REF NO.	AT04061	
DATE	Apr. 16, 2004	
(C)	Page 1 of 2

SUBJECT: IMPROVED TRANSMISSION LUBRICATION TUBE

PURPOSE: To introduce improved transmission lubrication tube with increased reli-

APPLICATION:

Fig. 1

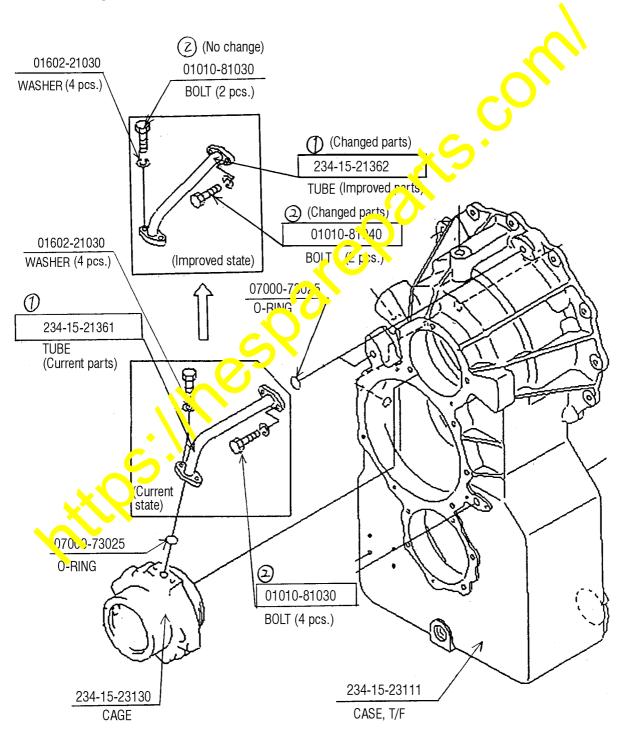
- (1) The shape of the lubrication tube ① has been changed to prevent entry of spatters caused at welding work.
 - Also, the connection method has been changed from welding to brazing to avoid the mounting stress caused by the welding strain and the resultant cracking which leads to oil leakage.
- (2) Pursuant to the change of the thickness of the tube flange, the mounting bolt ② has been changed.
